## Field Safety Notice

FA 2021-010-002-LUL-001

**Subject:** Missing bushing on Liko M220 and M230 causing wear and potential for falls.

**Commercial name of affected product:** Liko M220, Liko M230

Figure 1: Mechanism and parts included in the sling bar for M220/M230. Bushing marked in red.

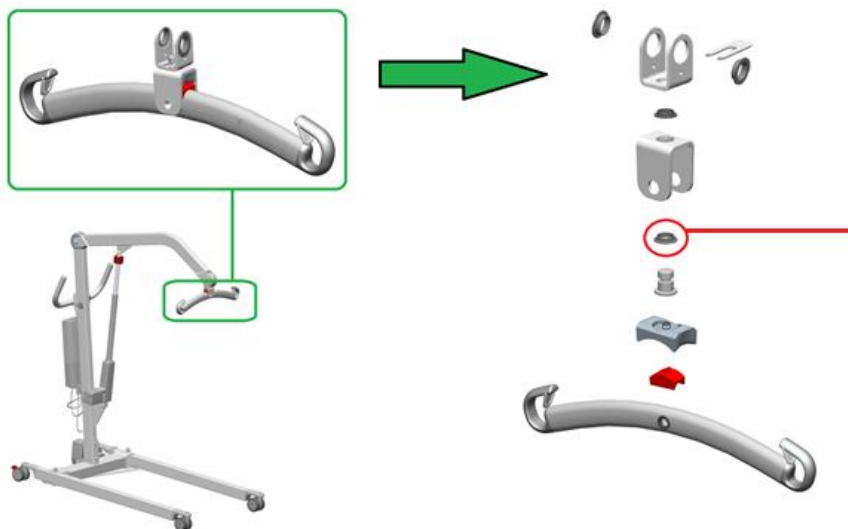
Hillrom has received customer complaints whereby a Slingbar had detached from the upper bracket of the sling bar attachment. Investigations indicated that a bushing was missing on the product. The missing bushing causes wear on the Slingbar attachment, which in turn can potentially cause the sling bar to detach from its attachment. If the slingbar detaches from the upper bracket, this has the potential for patient falls.

Hillrom investigation determined that the root cause of the slingbar detachment is caused by wearing at the slingbar attachment due to the missing of a plastic bushing (see red markings in Figure 1) as part of the assembly during manufacturing of the device. It was determined that assembly of this device has the potential to not contain this plastic bushing on devices manufactured between 2016-DEC-27 and 2021-SEP-01.

Upon receipt of the response form, identifying potentially impacted devices, Hillrom or an official Hillrom distributor/representative will be in contact to schedule inspection of your device to confirm presence of the bushing. Where it is confirmed that the device is missing the bushing, a replacement slingbar with the bushing will be installed.

Figure 2: Placement of the label and its designs. Left: New design. Right: Old design.

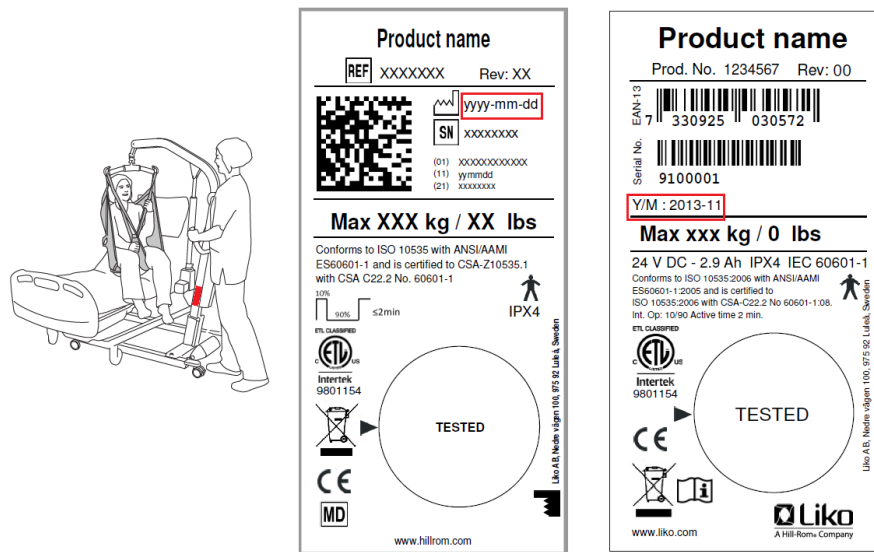
1. Review the product label on your Liko M220/M230 to determine if it is impacted by this field action by identifying the manufacturing date of the device (i.e. Manufacturing date between 2016-DEC-27 and 2021-SEP-01). See figure 2.
